SITE/SOIL EVALUATION ON-SITE

SITE PLAN APPROVAL

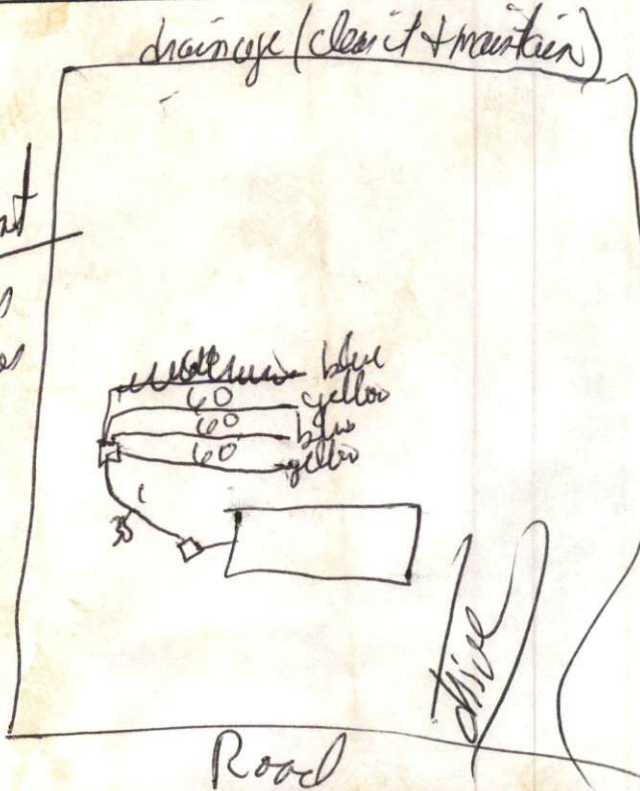
Layout
3x110 lines
18-22' ditches on contour

move house 10 feet toward road

Pump to Comp. Repair
